TRANS/WP.29/2002/39
11 April 2002

World Forum for Harmonization of Vehicle Regulations (WP.29)
(One-hundred-and-twenty-seventh session,
25-28 June 2002, agenda item 4.2.17.)

PROPOSAL FOR DRAFT SUPPLEMENT 5 TO REGULATION No. 101

(Emission of CO₂ and fuel consumption measurement)

Figure 8/1: Parameters measured during carbon dioxide emission and fuel consumption test during and between cycles where regeneration occurs (schematic example, the emissions during 'D' may increase or decrease)

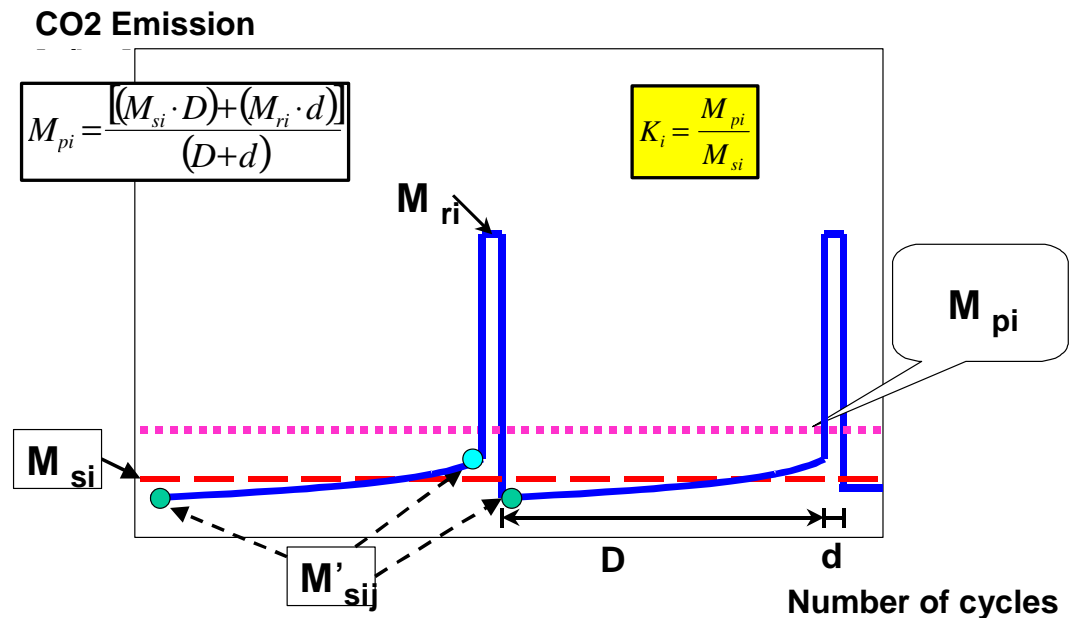
Add a new annex 8, to read:

"Annex 8

EMISSIONS TEST PROCEDURE FOR A VEHICLE EQUIPPED WITH
A PERIODICALLY REGENERATING SYSTEM

For exemplary illustration of measurement parameters see figure 8/1.
